Technical Service Bulletin: TSB170079	Released Date: 02-Apr-2018
Incorrect Aftertreatment Part Number Etching

- B6.7 CM2350 B121B
- L9 CM 2350 L116B
- X15 CM2350 X114B

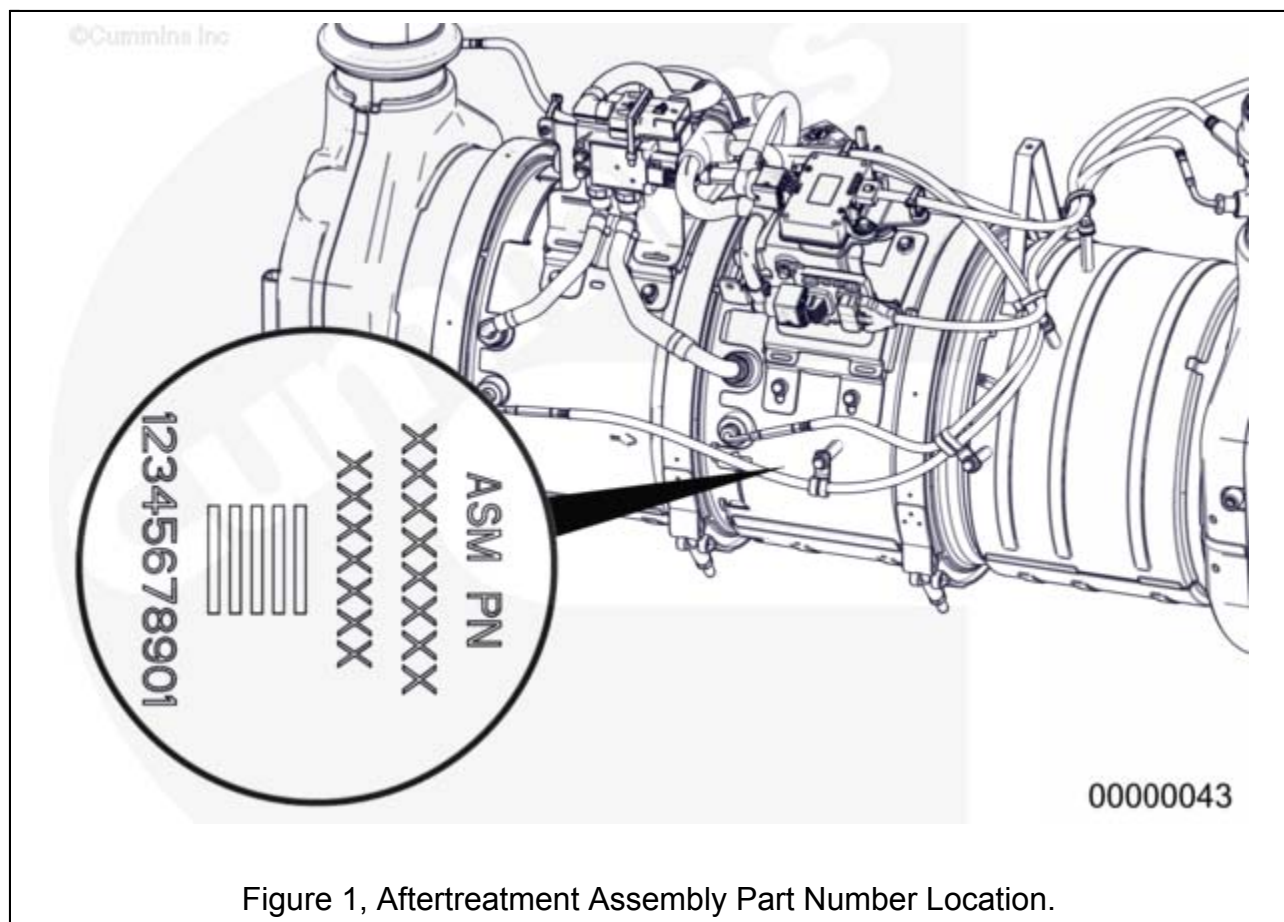
- Figure 1 below displays location of entire assembly part number, which can guide in further identification of needed individual parts.
- Figure 2 below displays location of E PN and C PN on aftertreatment DOC.
- More information about part number identification and location can be found in the corresponding service manual.
 - See B6.7 CM2350 B121B Service Manual, Bulletin 5411223. Refer to Procedure 100-001 (</qs3/pubsys2/xml/en/procedures/455/455-100-001.html>) in Section E.
 - See L9 CM2350 L116B Service Manual, Bulletin 5411330. Refer to Procedure 100-001 (</qs3/pubsys2/xml/en/procedures/459/459-100-001.html>) in Section E.
 - See X15 CM2350 X114B Service Manual, Bulletin 5411181. Refer to Procedure 100-001 (</qs3/pubsys2/xml/en/procedures/377/377-100-001.html>) in Section E.
